January 2021 BAR Decision

BAR 21-01-04

301 East Jefferson Street

Project: Renovations to 3rd Street NE and East Jefferson Street entries

SANCTUARY ENTRANCE - PLAN

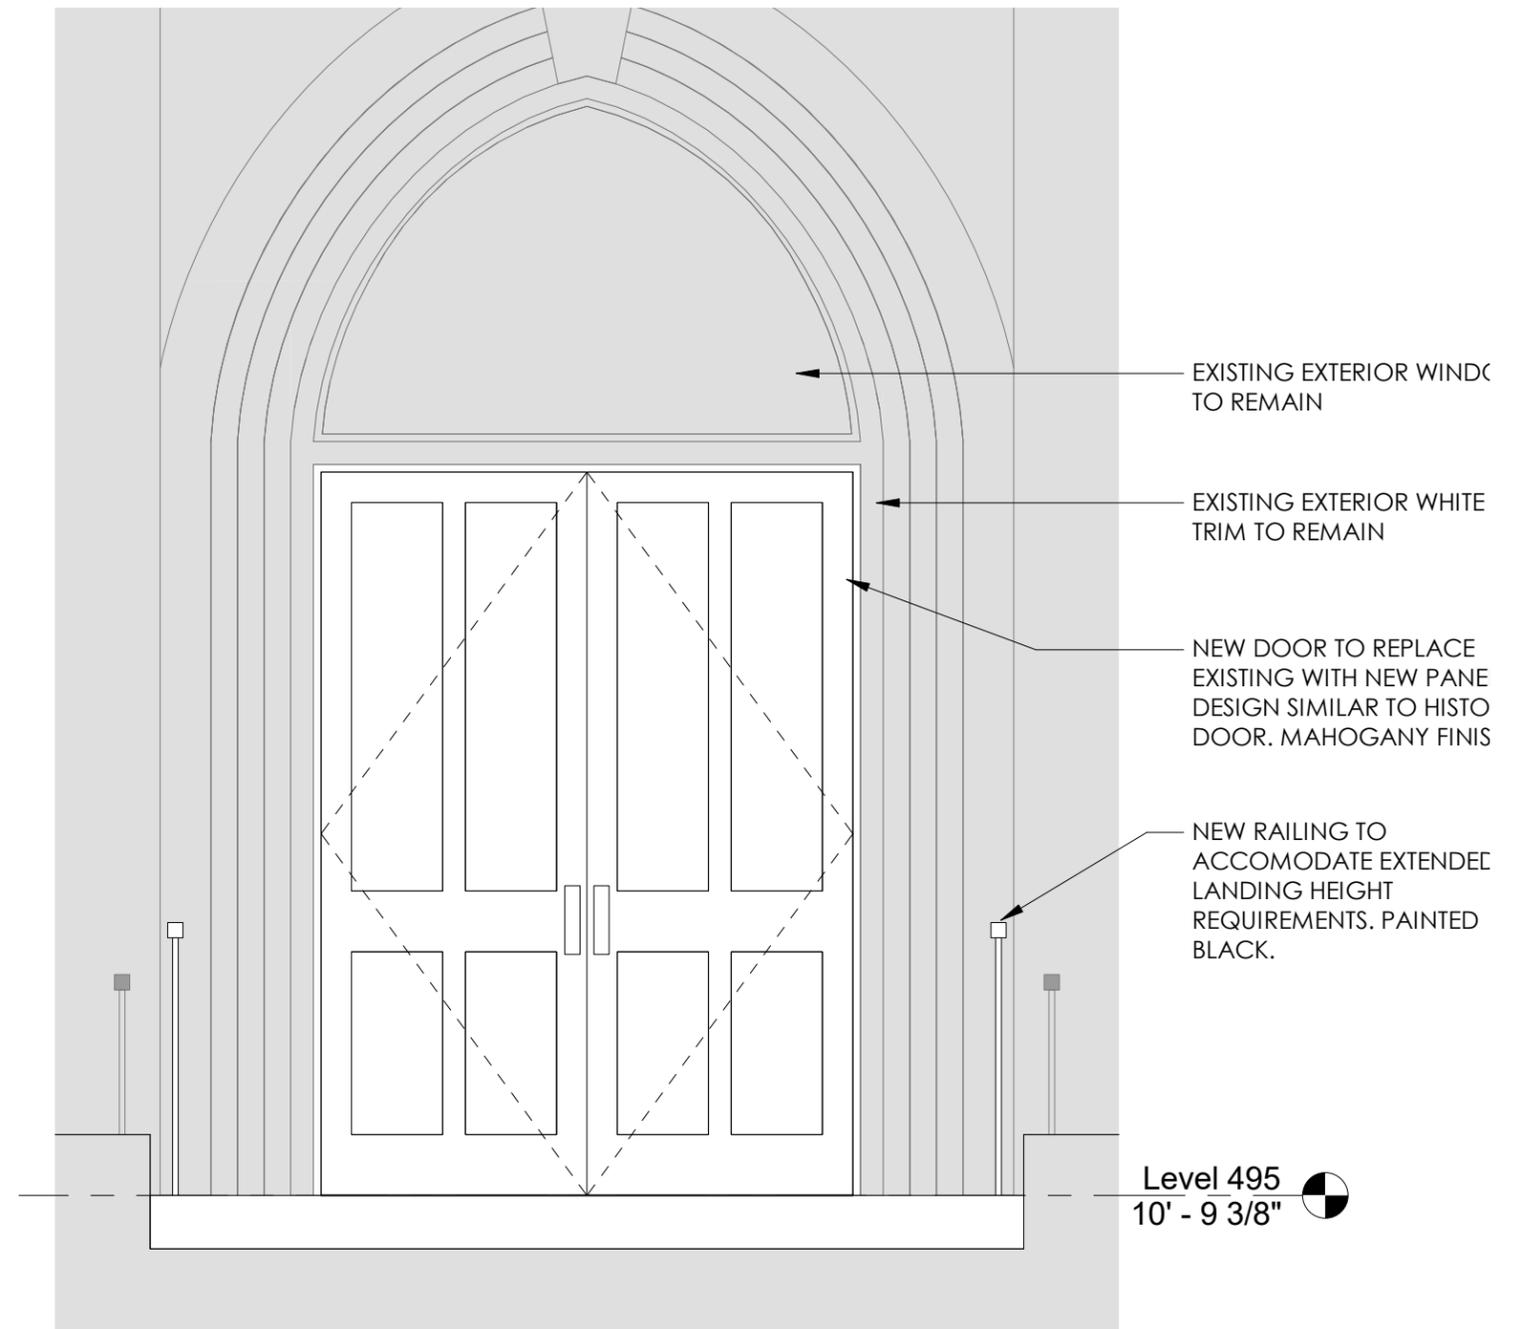
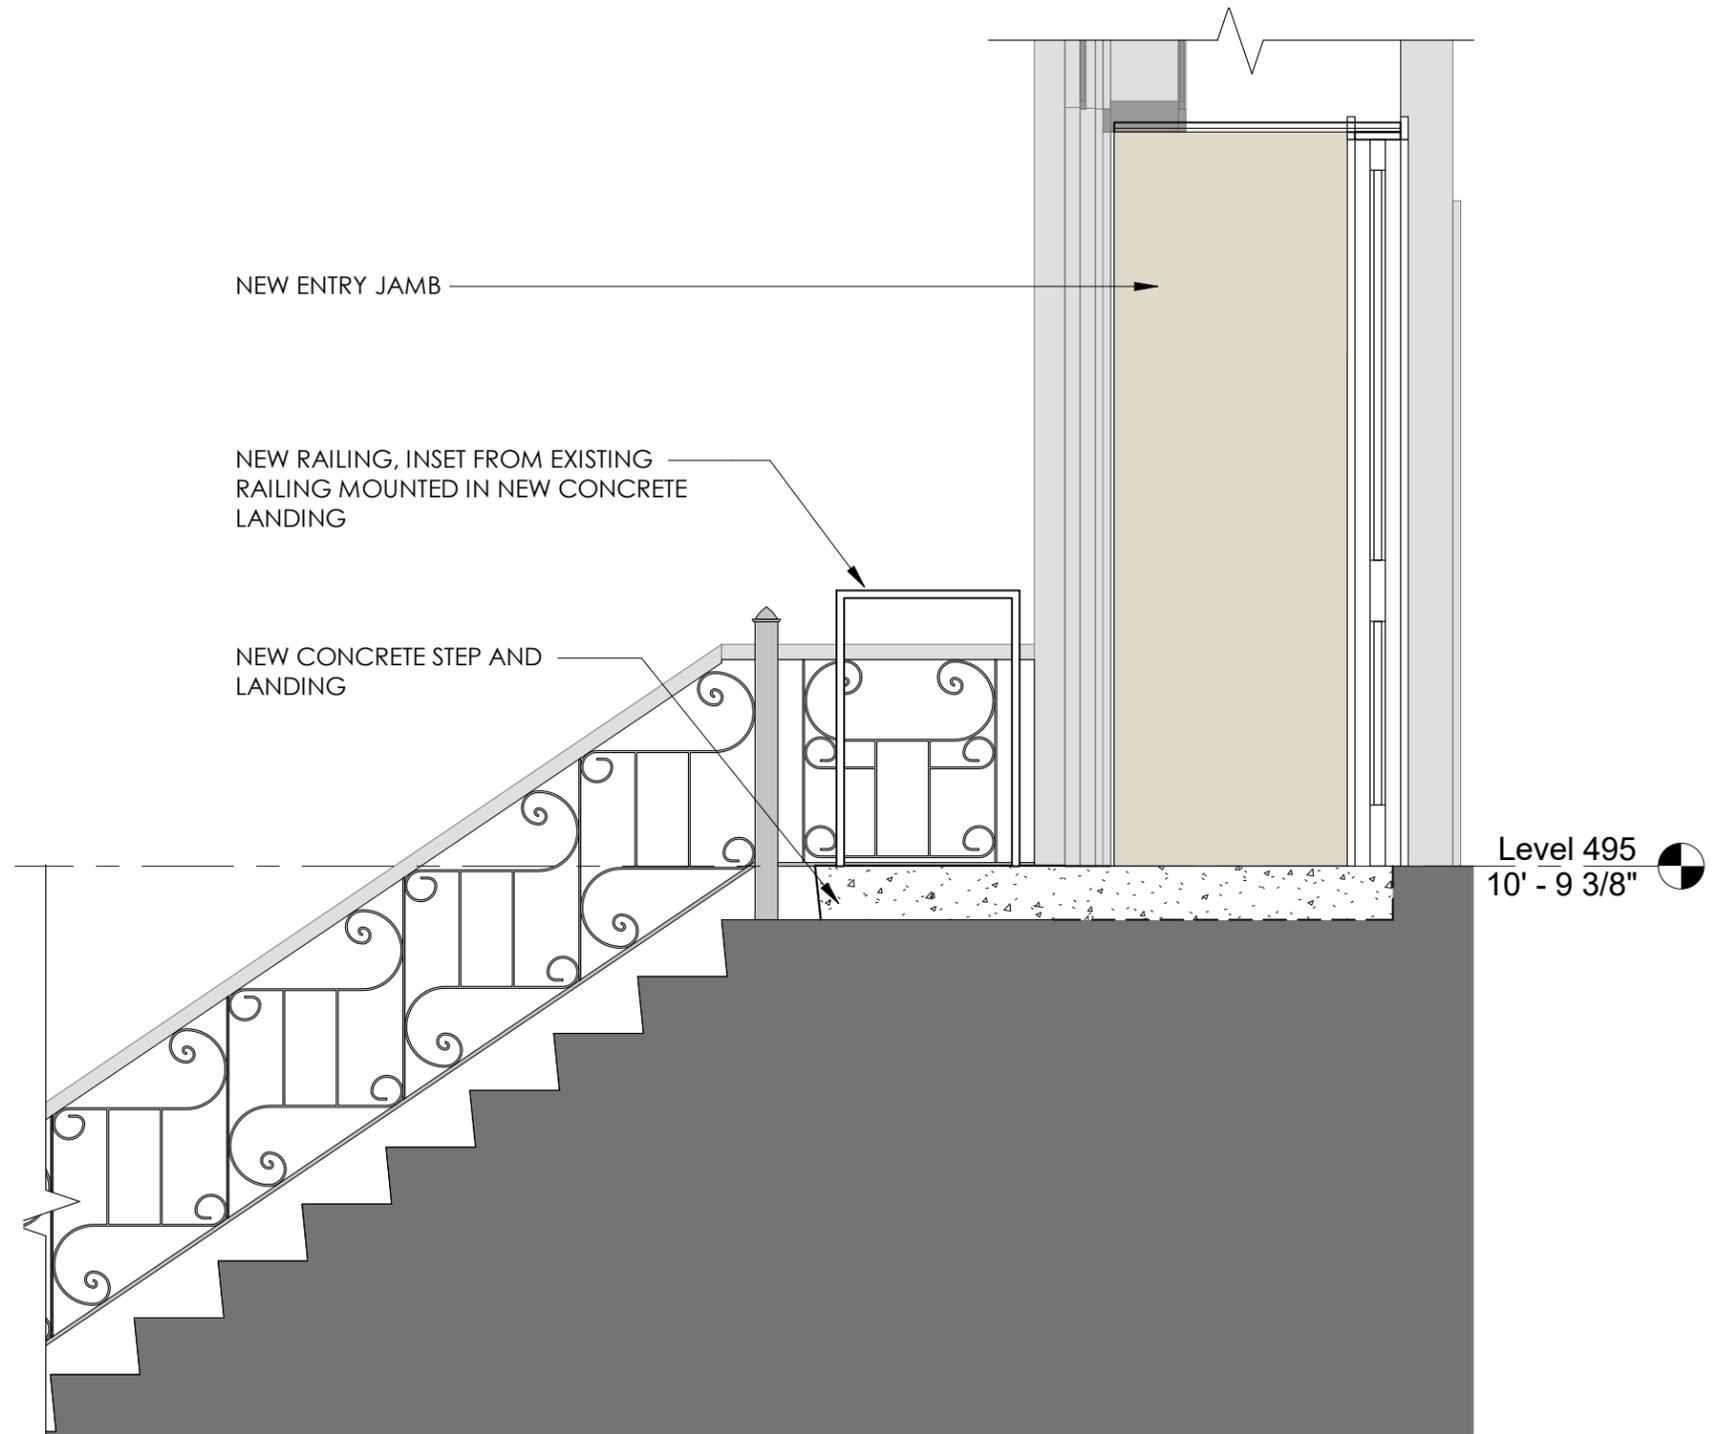
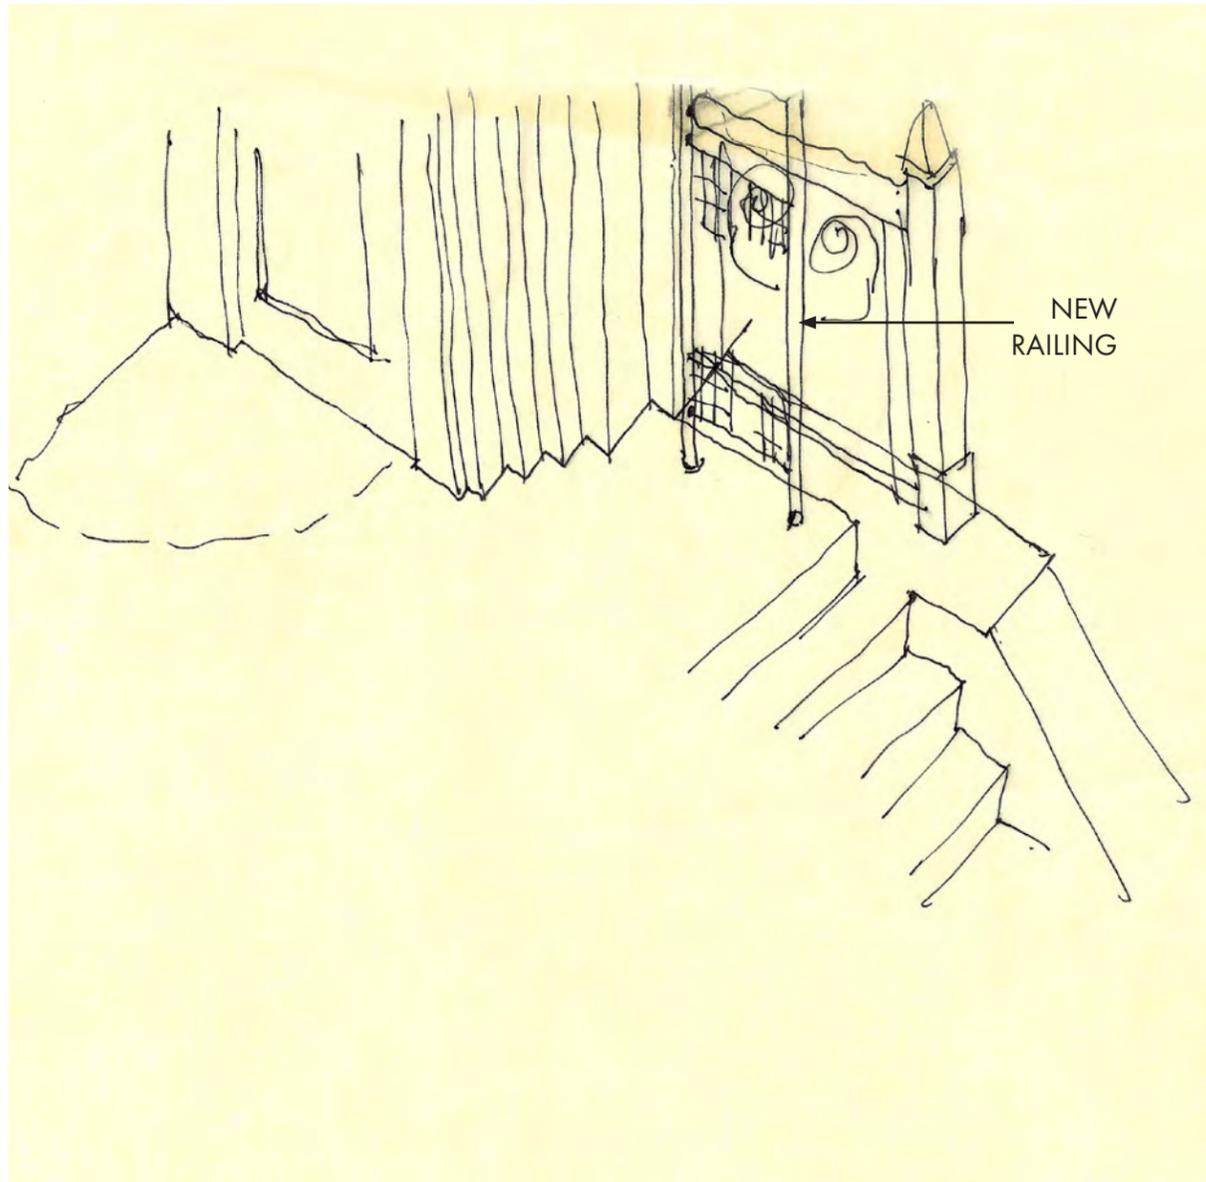
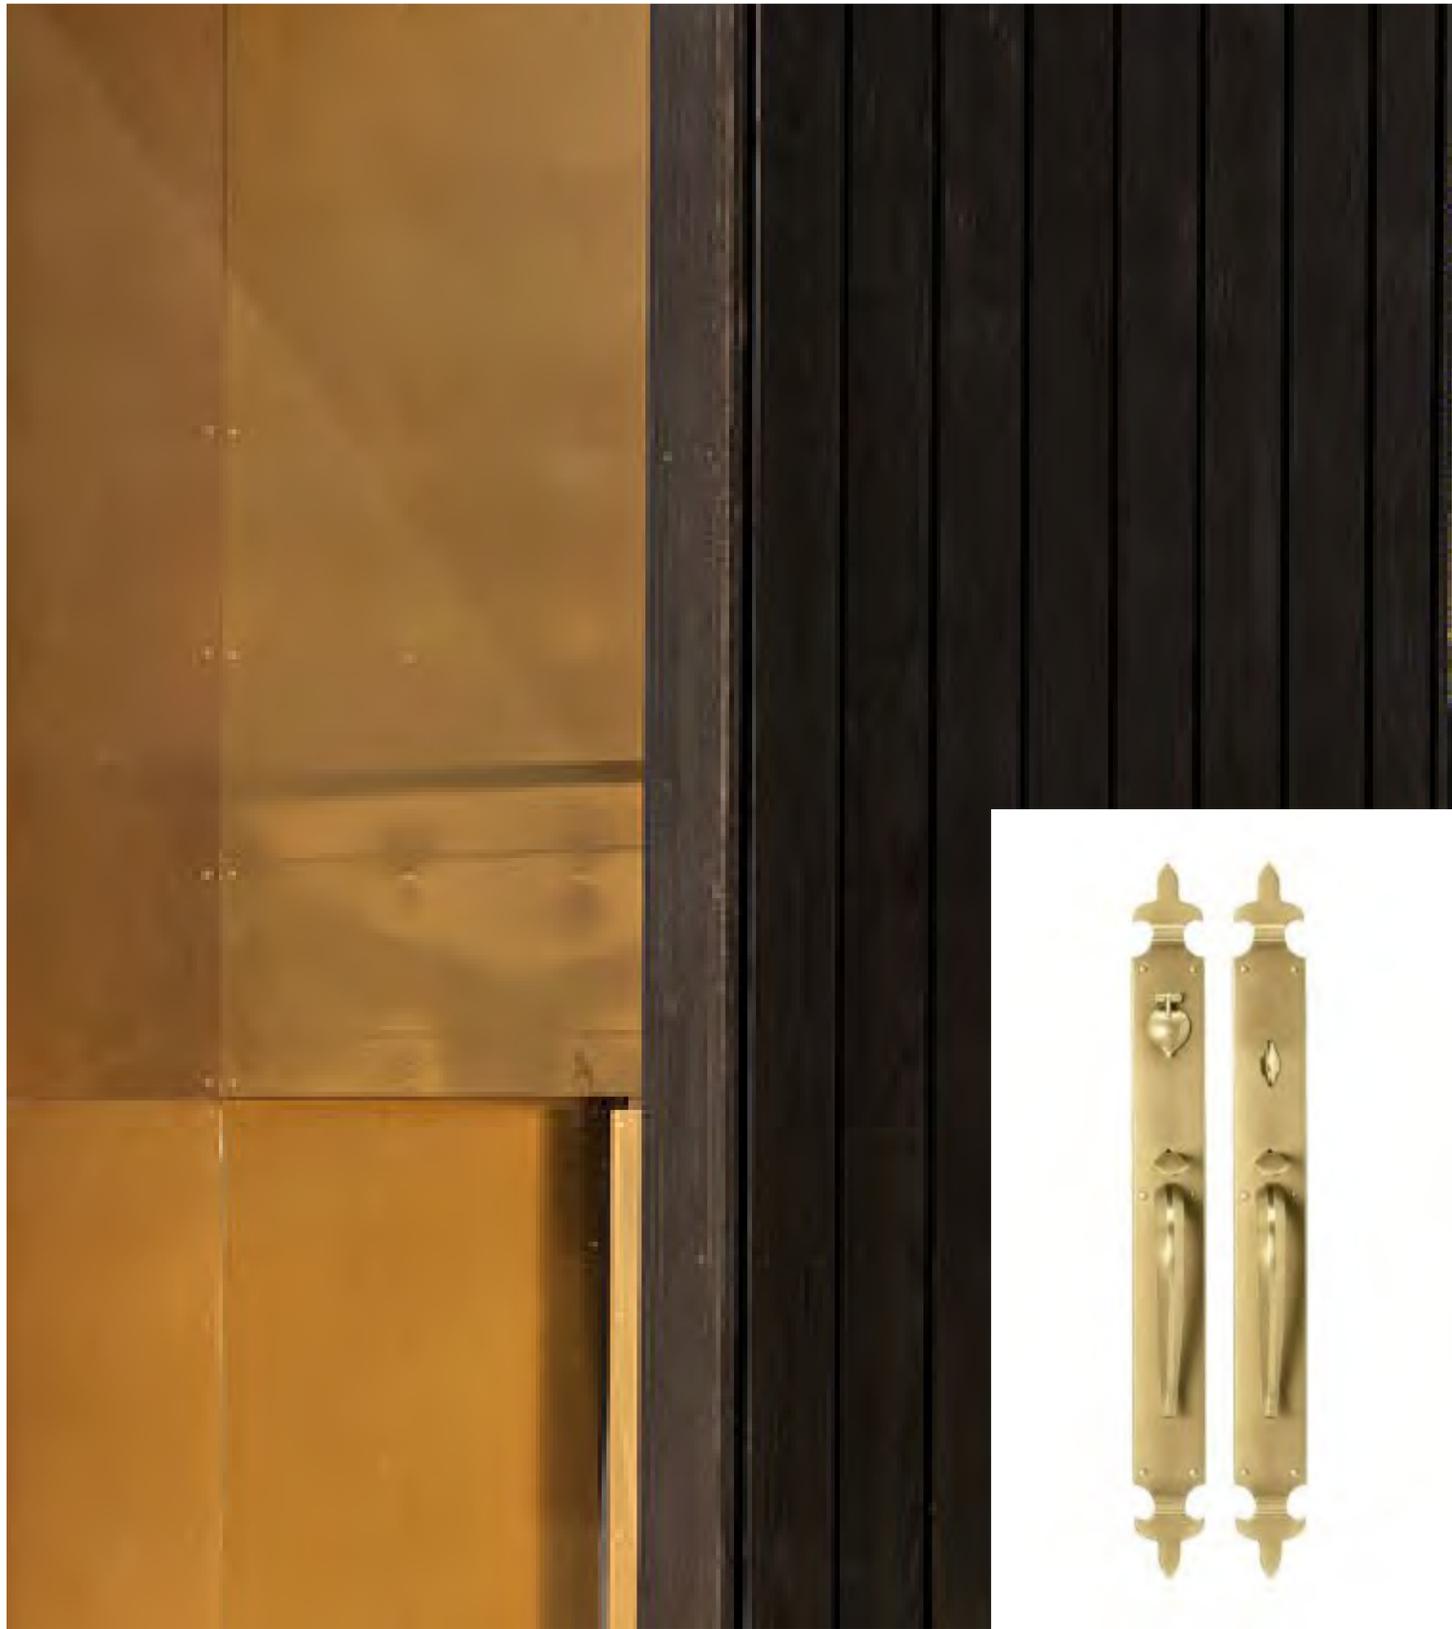
Sanctuary entrance. Staff applied the design guidelines for Rehabilitation. Replacement of historic elements should be avoided; however, the existing doors are not believed to be original and the proposed new doors are consistent with the guidelines. Staff recommends approval.

Direction is less clear for the proposed railing extensions, which might damage the historic material. Staff reviewed the Secretary's Standards; however, that guidance addresses these situations only relative to building and safety code compliance, which is not the situation here. Ideally, the solution is a second railing that is not anchored onto/into the original rail or the historic brick. Otherwise, staff recommends approval with a condition that the new railing be attached to the original in a manner that minimizes damage to the existing.

Having considered the standards set forth within the City Code, including the ADC District Design Guidelines, I move to find that the proposed entrance alterations at 301 East Jefferson Street satisfy the BAR's criteria and are compatible with this property and other properties in the North Downtown ADC District, and that the BAR approves the application as submitted.
